ABLE HUMBER PORTS LTD

RELEVANT REPRESENTATION ON THE PROPOSED IMMINGHAM EASTERN Ro-Ro TERMINAL

PINS REFERENCE TR030007

Map 1:

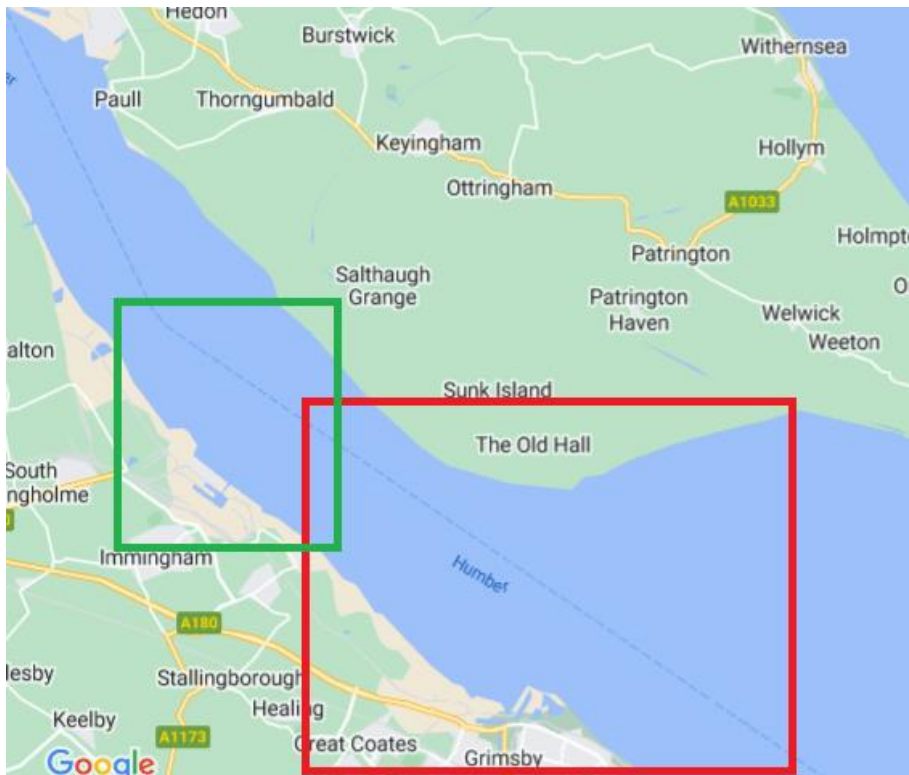
- 3.3.3 Map 1 below shows the relative locations of Map 2 (green) and Map 3 (red). Map 2 is taken from the Applicant's Environmental Statement (Volume 2, Chapter 2 [[APP-060](#)], figure 2.2) and shows deposit sites HU056 and HU060. Map 3 is taken from Able's Environmental Statement for its Marine Energy Park and shows deposit sites HU080, HU081 and HU082.

Figure 8.3 *Proposed disposal sites in the Humber Estuary (©OS OpenData™), reproduced from Annex 8.1 (JBA, 2011)*

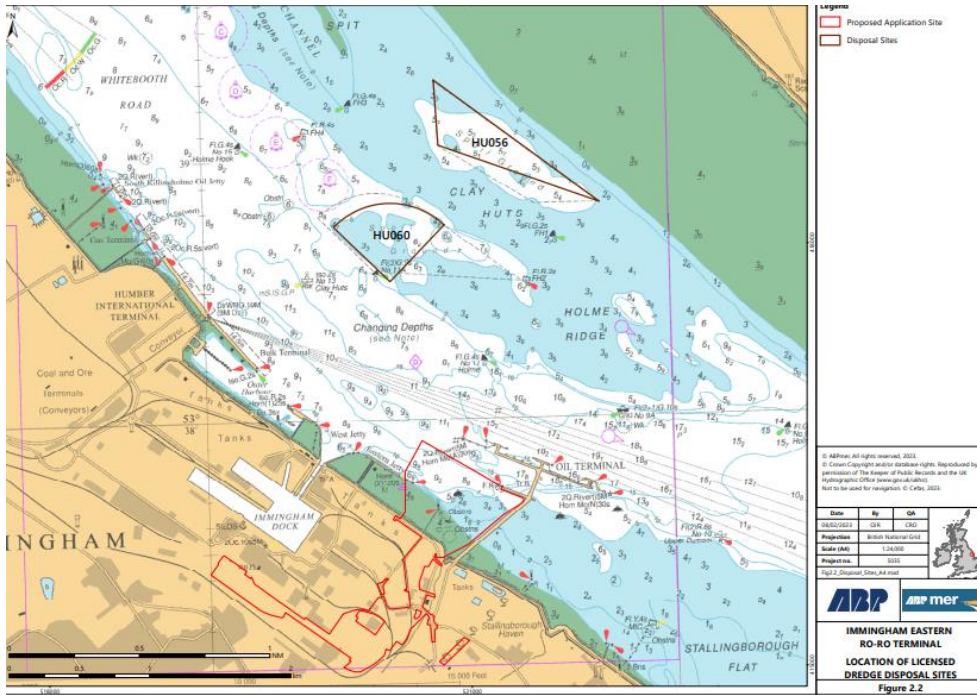
- 3.3.1 The proposed deposit sites are relatively small and are already commonly used for the disposal of material from maintenance dredging campaigns for the Immingham and Killingholme areas. Able is concerned that the disposal of this quantity of material in these two deposit grounds could seriously reduce the capacity to accept material from the continual maintenance dredging campaigns forcing the dredgers carrying out such maintenance dredging campaigns to use other deposit grounds therefore reducing their efficiency and availability.

- 3.3.2 Able is concerned that the disposal of such a quantity of dredge material so close to the Immingham area is likely to find its way back at the south Humber bank and increase siltation there, which could interfere with the construction and subsequent operation of the Able Marine Energy Park. It is of note that the deemed marine licence in Able's own DCO authorises the deposit of dredge arisings at different sites HU080, HU081 and HU082, further downstream towards the mouth of the Humber Estuary, as shown in Map 3 below, extracted from the AMEP Environmental Statement (Chapter 8). Able would wish to see protective provisions whereby any increased dredging requirement at its facility due to this project be paid for by the Applicant.
